FINAL DRAINAGE REPORT FOR RETREAT AT TIMBERRIDGE FILING NO. 2

CCES RESPONSES

PCD Project No. SF-21-021

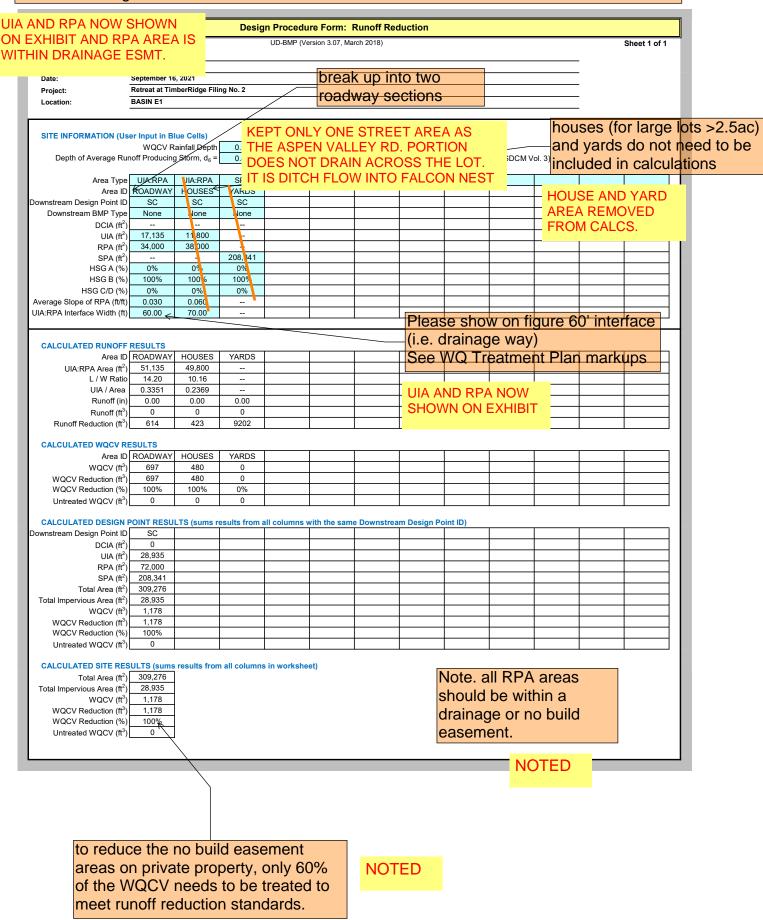
provide a figure showing all proposed UIA and RPA areas to be utilized for runoff reduction. All RPA areas will need to be within a no build/drainage easement and discussed in the maintenance agreement and O&M Manual. Unresolved.

Lots 6, 8, and 9 are part of Exclusion E and do not need runoff reduction calculations.

Figure 13-12c. Emergency Spillway Protection

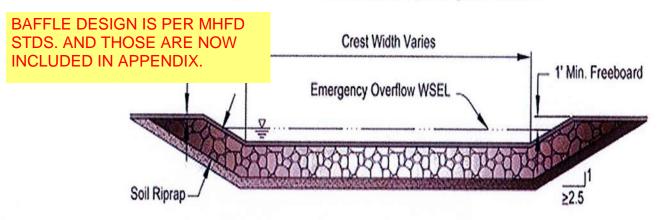
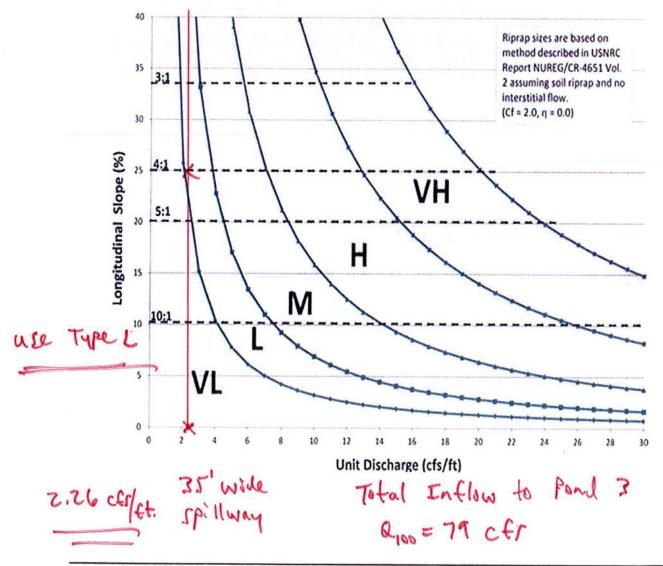
Include calculations for T-baffle in forebay
